Groundwater Transfer Review Summary Form

Transfer/PA # T- 14464

Application: T-14464

Applicant Name: Spring Creek Land and Cattle Co., LLC

Map

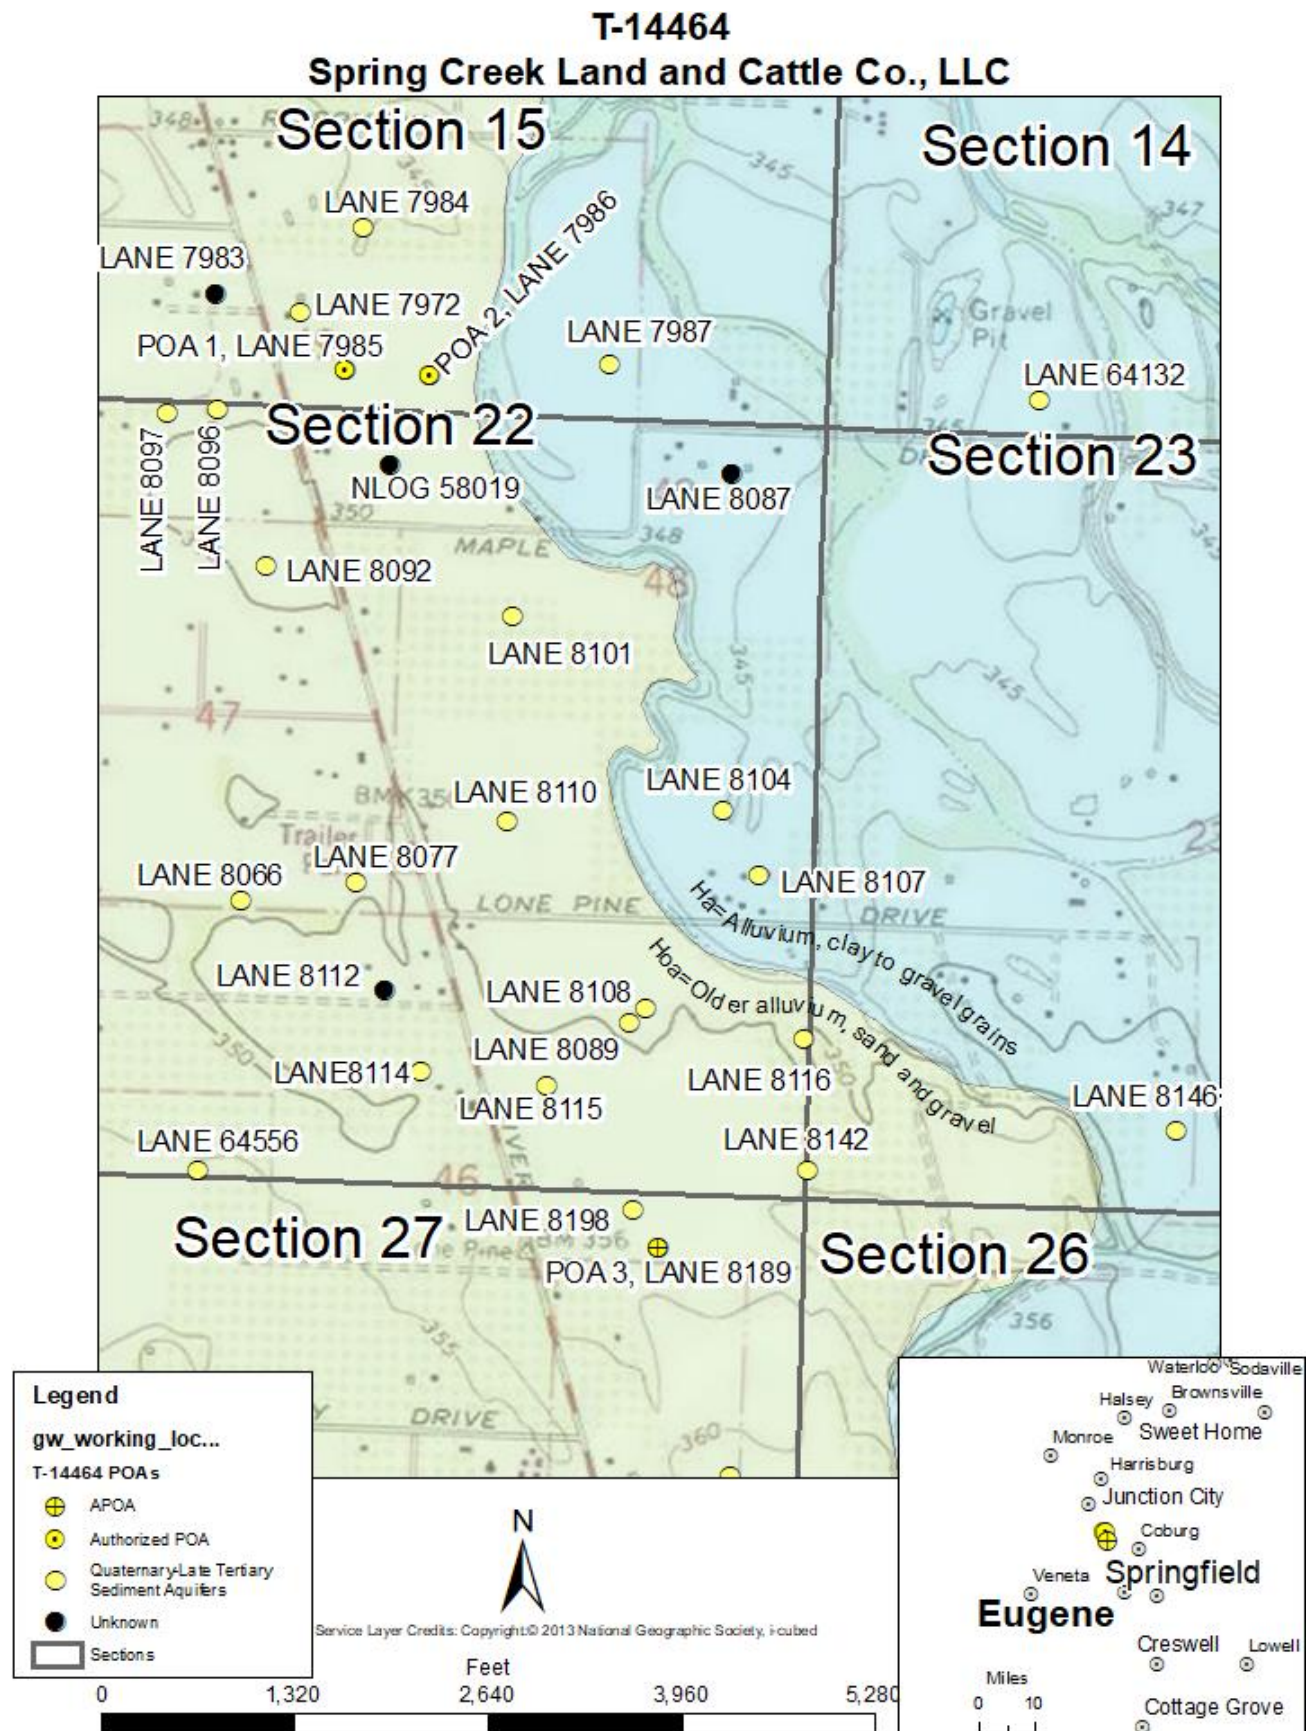
2. Will the proposed POA develop the same aquifer (source) as the existing authorized POA?
☒ Yes ☐ No Comments: The authorized POAs (LANE 7985, LANE 7986) likely develop a shallow quaternary floodplain gravel and sand lens with water level elevation between 340 and 360 ft amsl (McCloughry et al., 2010; O'Connor et al., 2001; Wallick et al., 2013; Woodward et al., 1998); the wells develop a water bearing zone from 18 to 21 ft bls [330 to 333 ft amsl]. The proposed APOA (LANE 8189) develops a similar shallow floodplain deposit with sand and gravel water bearing zones developed from 21 to 25 ft bls [333 to 337 ft amsl] and a water level elevation of 13 ft bls [345 ft amsl].

5. a) Will this proposed change, at its maximum allowed rate of use, likely result in an increase in interference with **another ground water right**?
☒ Yes ☐ No Comments: The proposed APOA (LANE 8189) is closer to LANE 8198, authorized under Claim GR-1261. The closer proximity will likely increase interference.

6. a) Will this proposed change, at its maximum allowed rate of use, likely result in an increase in interference with **another surface water source**?
☐ Yes ☒ No Comments: The authorized POAs (LANE 7985, LANE 7986) are closer to surface water sources than the proposed APOAs. The increased distance is anticipated to decrease interference.

Theis Interference Analysis

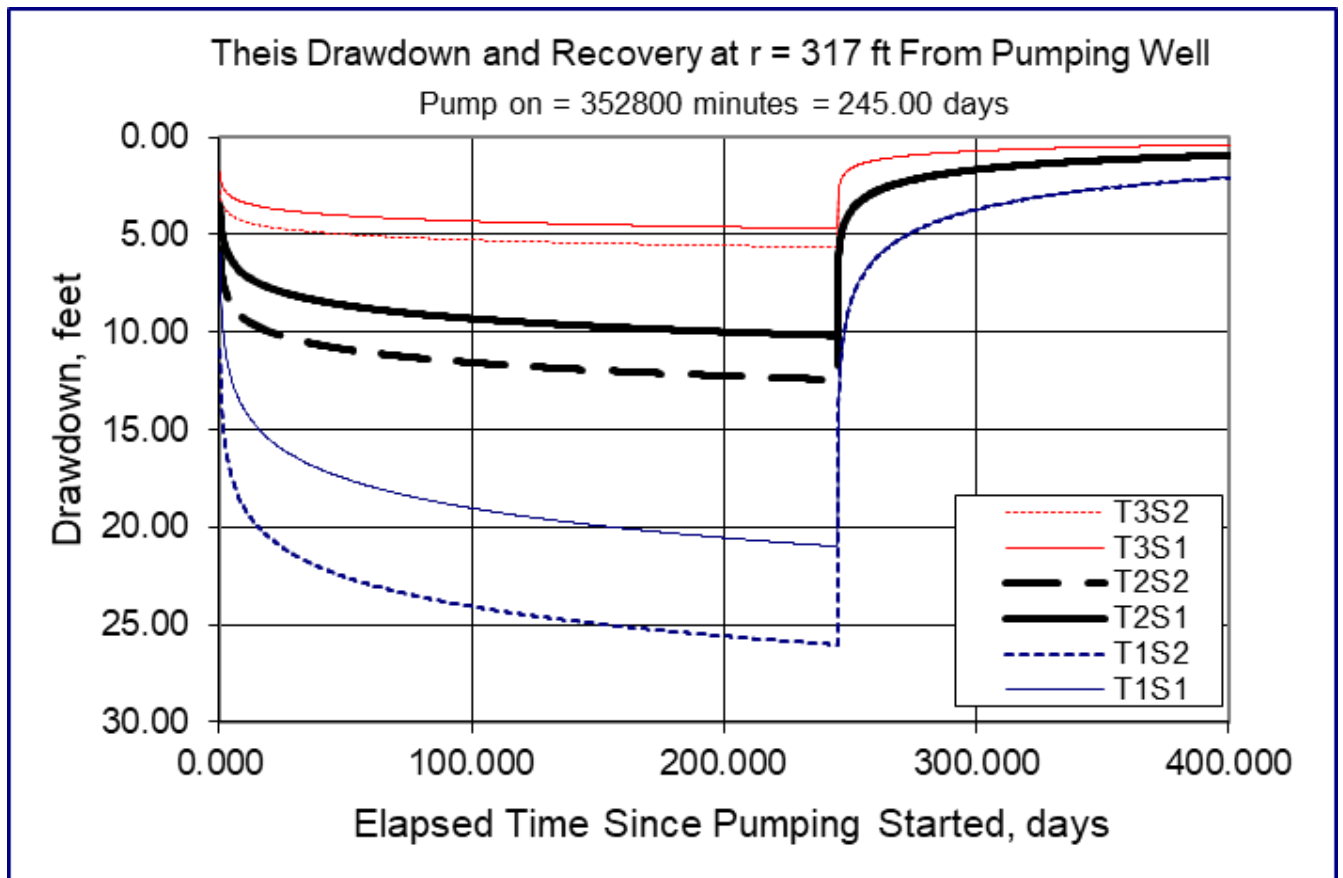
- b) If yes, would this proposed change, at its maximum allowed rate of use, likely result in another groundwater right not receiving the water to which it is legally entitled?
☐ Yes ☒ No If yes, explain: Proposed APOA (LANE 8189) is 317 ft southeast of LANE 8198. The Theis (1935) solution was used to assess interference from proposed APOA (LANE 8189) to LANE 8198 (see attached Theis Interference Analysis). Results indicate that the proposed change is unlikely to injure LANE 8198.
